**REQUEST FOR AMENDMENT TO TECHNICAL SPECIFICATIONS
TO INCREASE POWER LEVEL FROM 3323 MWt TO 3486 MWt,
SUPPLEMENTARY INFORMATION**

**TECHNICAL SPECIFICATION PAGES
and BASES CHANGES**

Two power/flow maps are provided for Figures 3.2.6-1, 3.2.7-1, 3.2.8-1, and 3.4.1.1-1. The first map reflects the present Technical Specification power/flow map with the proposed changes superimposed for comparison and the second shows only the proposed power/flow map.

Figure 3.2.6-1

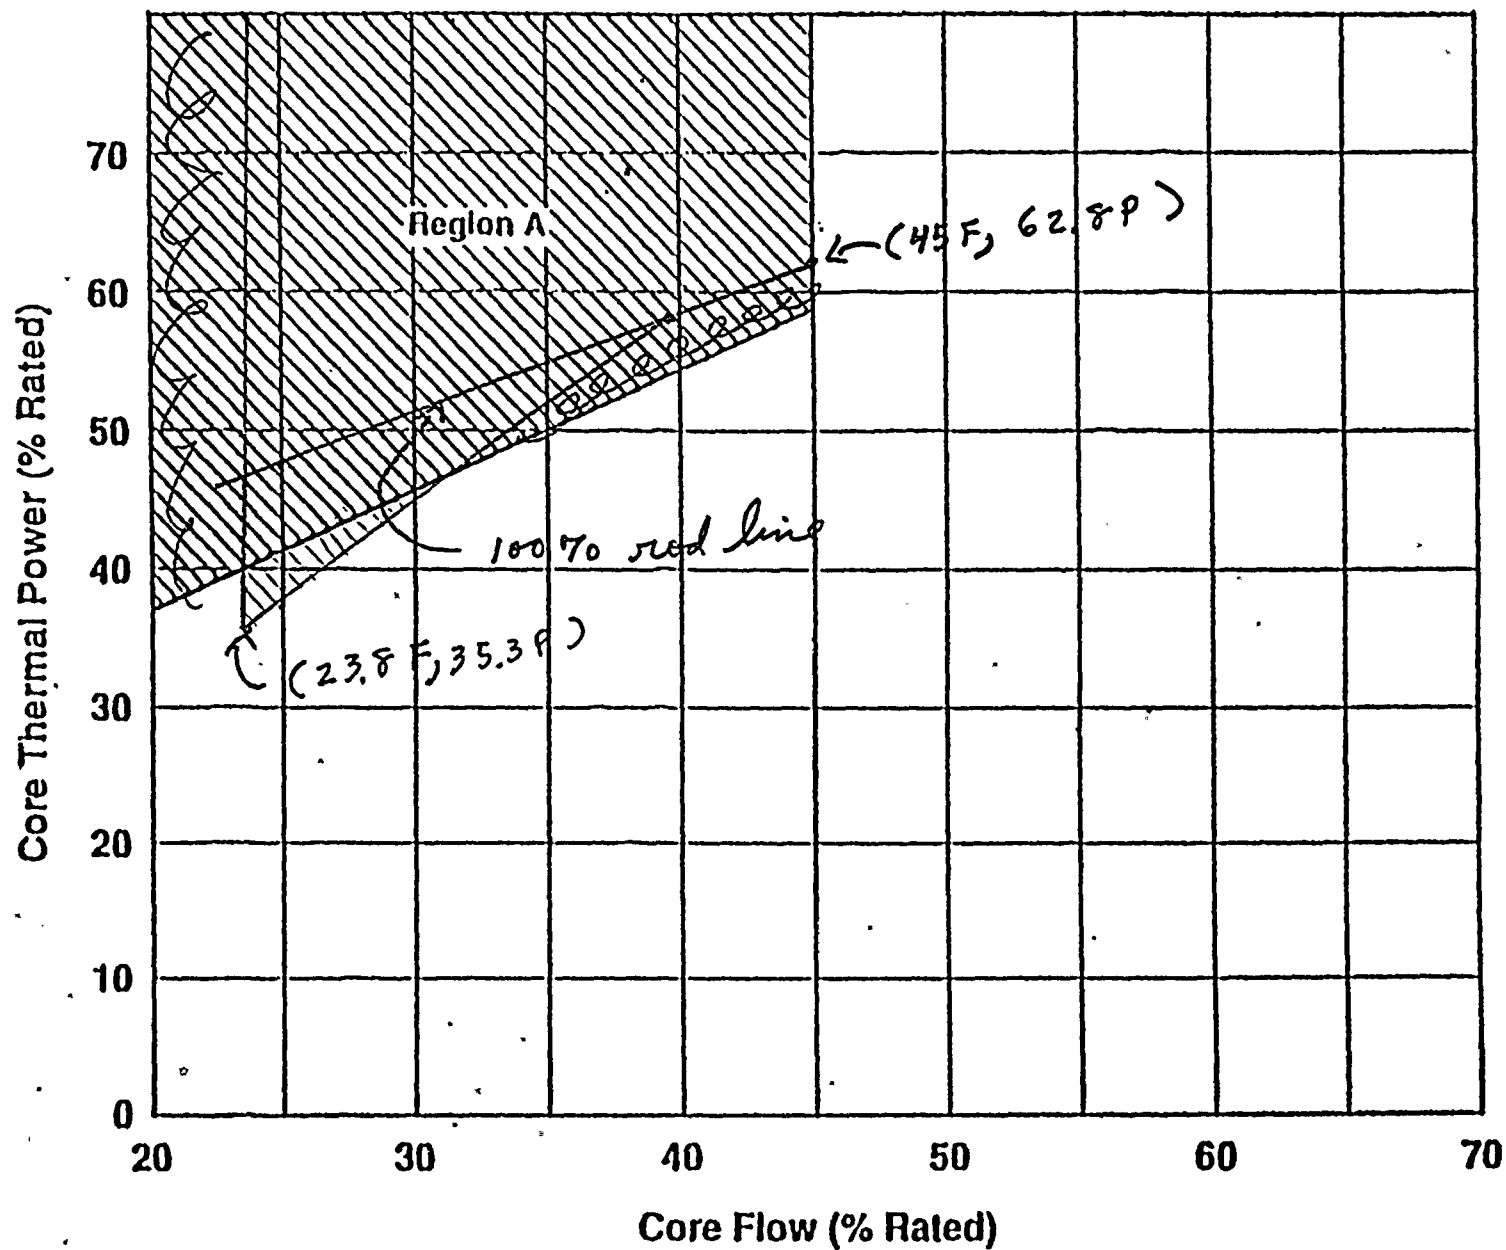
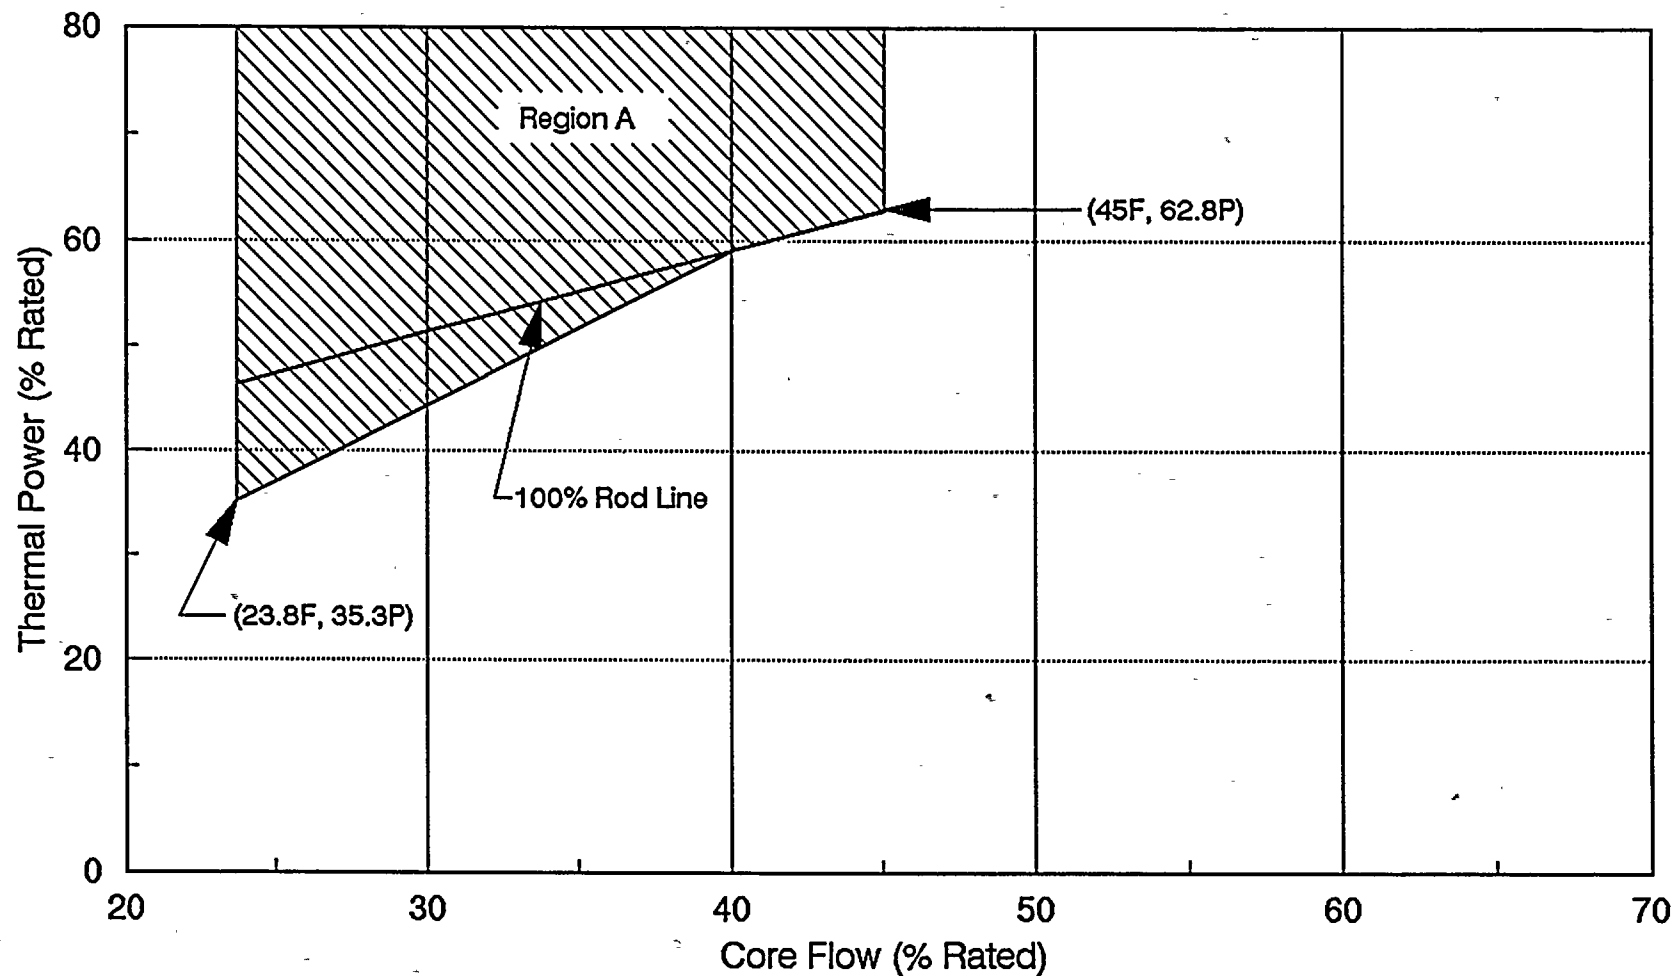
APPLICABILITY: OPERATIONAL CONDITION 1, when THERMAL POWER is greater than ~~39%~~ of RATED THERMAL POWER and core flow is less than or equal to 45% of rated core flow.

35.3%

Reviewer: Please note that this value comes directly from the proposed power flow map 3.2.6-1.

Figure 3.2.7-1

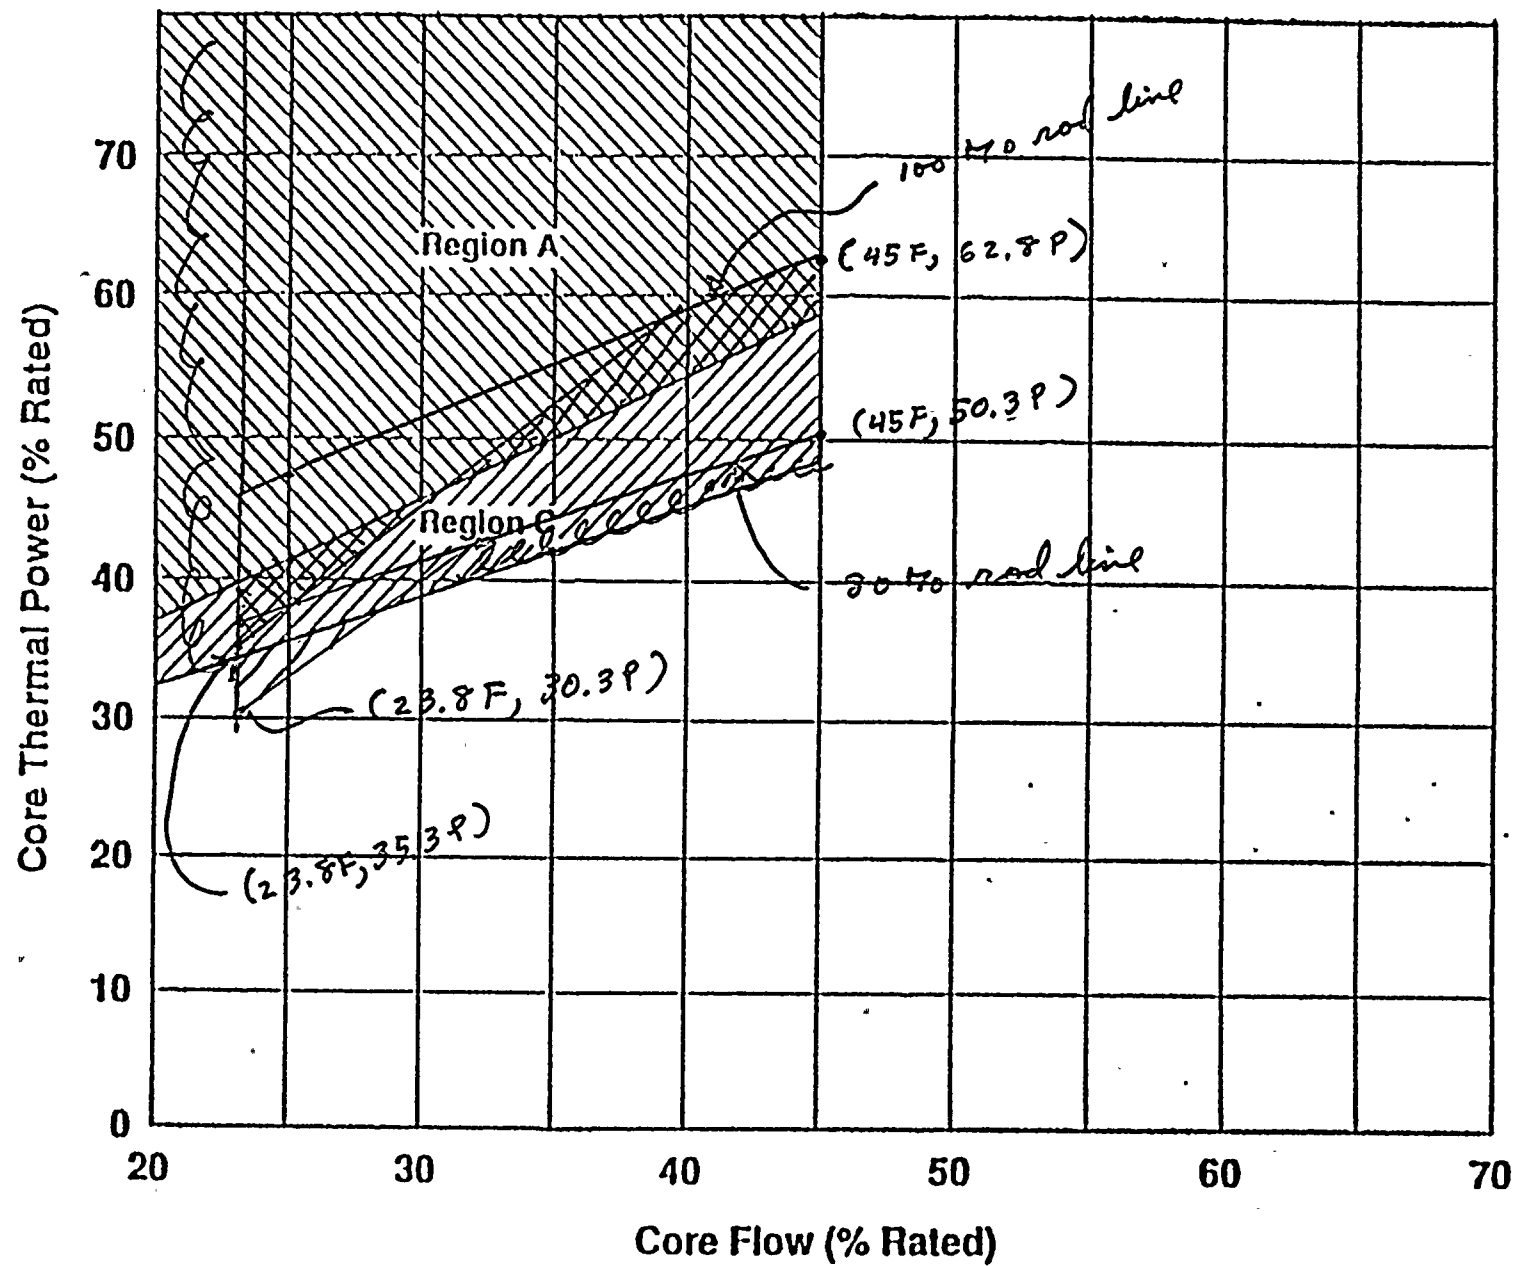
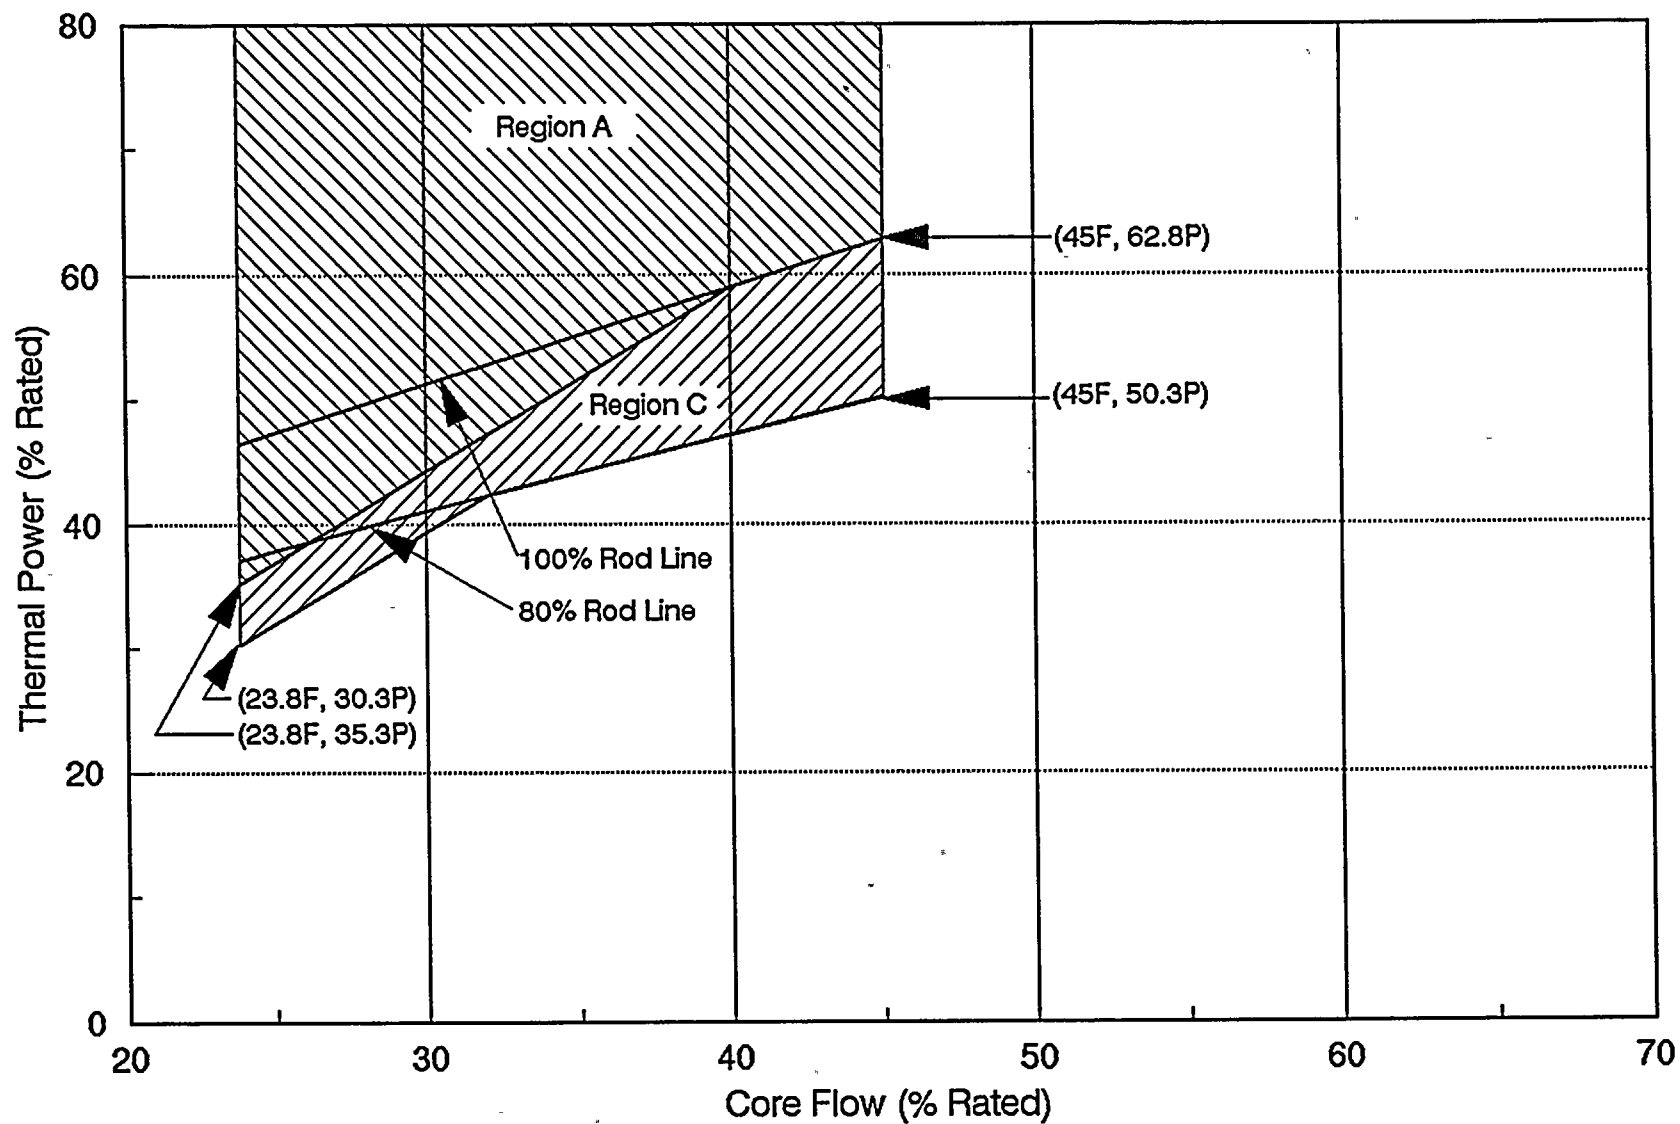
or equal to 0.75
As soon as practical, but in all cases within 15 minutes, initiate action to reduce the decay ratio by either decreasing THERMAL POWER with control rod insertion or increasing core flow with recirculation flow control valve manipulation. The starting or shifting of a recirculation pump for the purpose of decreasing decay ratio is specifically prohibited.

Figure 3.2.8-1

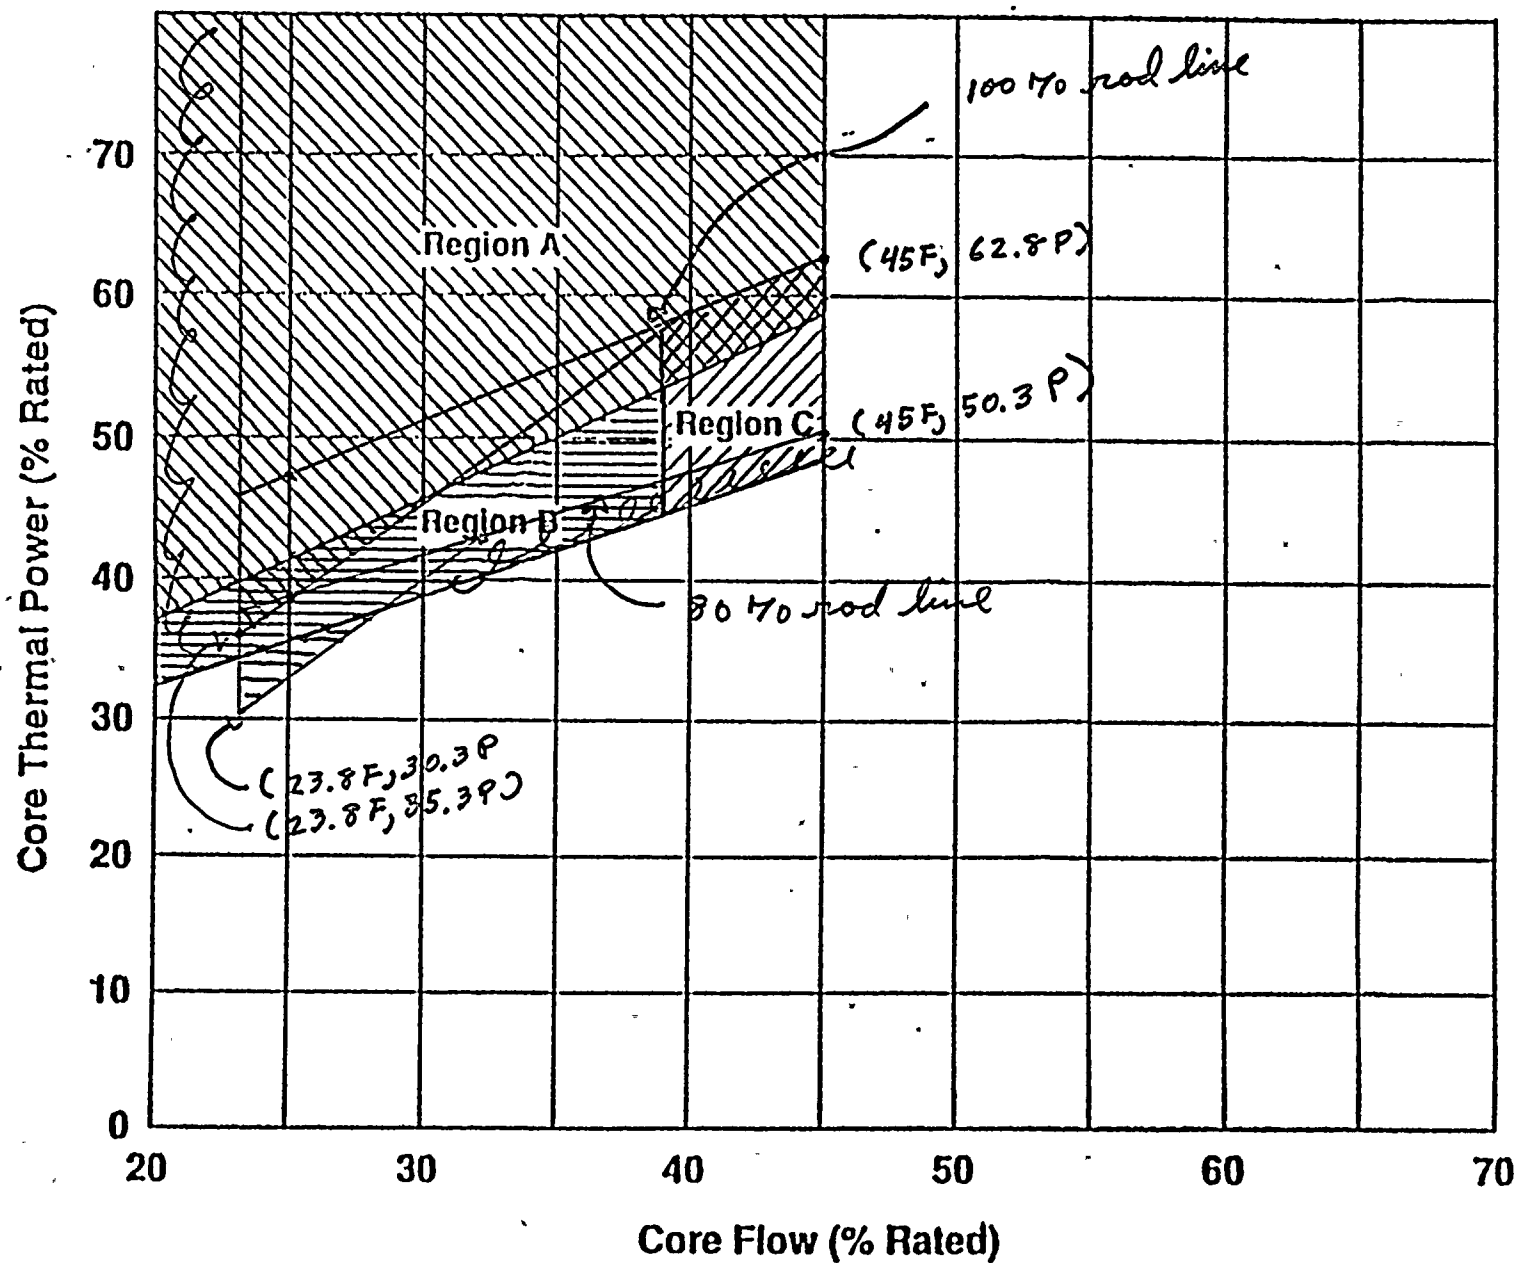
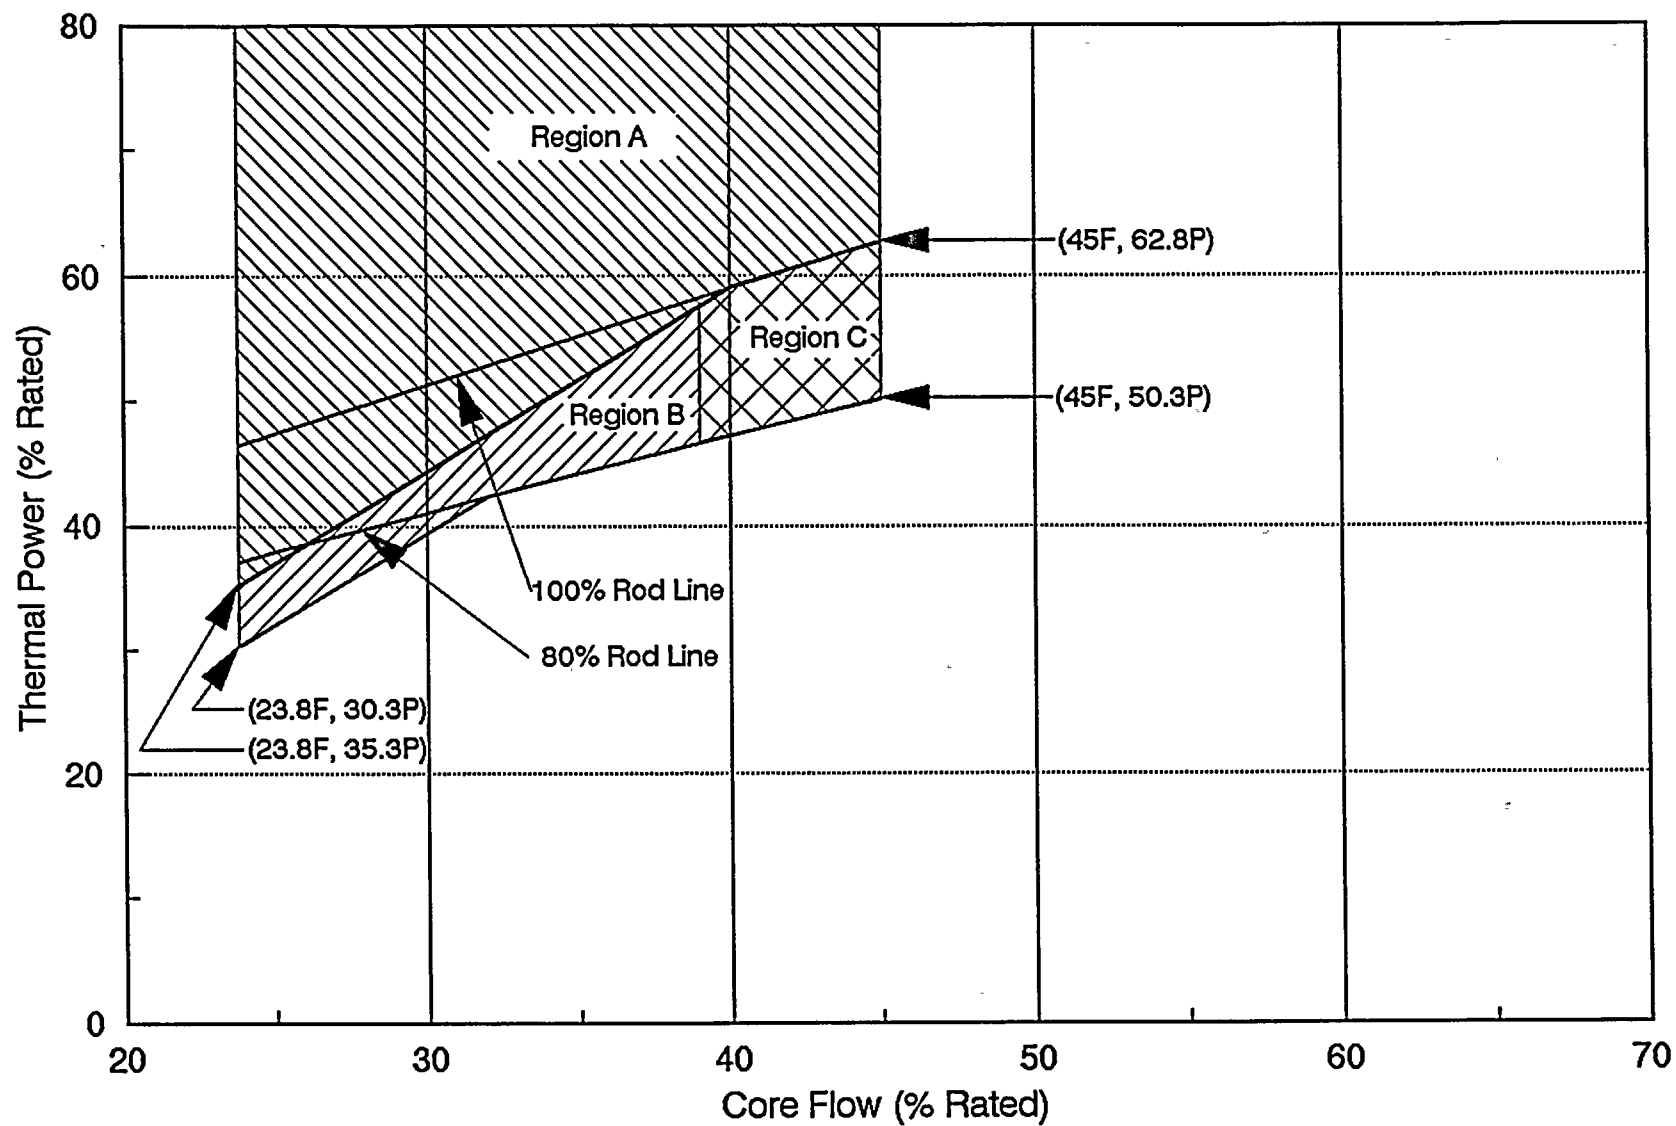
- a. With decay ratios of any two (2) neutron signals greater than ^{or equal to 0.75} .75 or with two (2) consecutive decay ratios on any single neutron signal greater than .75:

^{or equal to 0.75} As soon as practical, but in all cases within 15 minutes, initiate action to reduce the decay ratio by either decreasing THERMAL POWER with control rod insertion or increasing core flow with recirculation flow control valve manipulation. The starting or shifting of a recirculation pump for the purpose of decreasing decay ratio is specifically prohibited.
